CORRIGENDUM 1

Figure 1 – Separation of intrinsically safe and non-intrinsically safe terminals

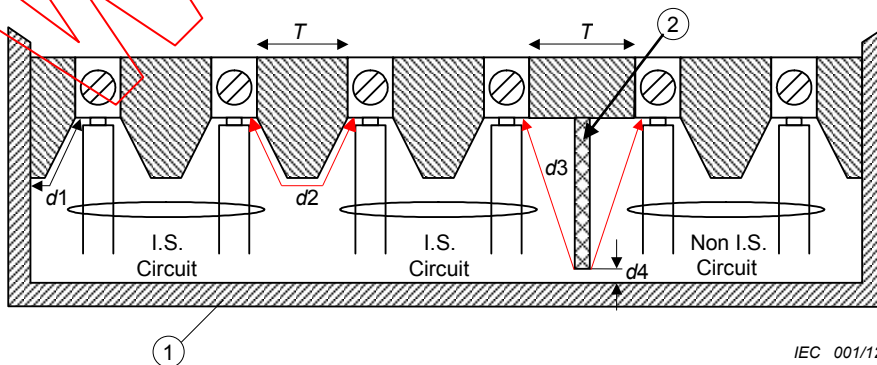
Replace the drawing in Figure 1b by the following drawing:
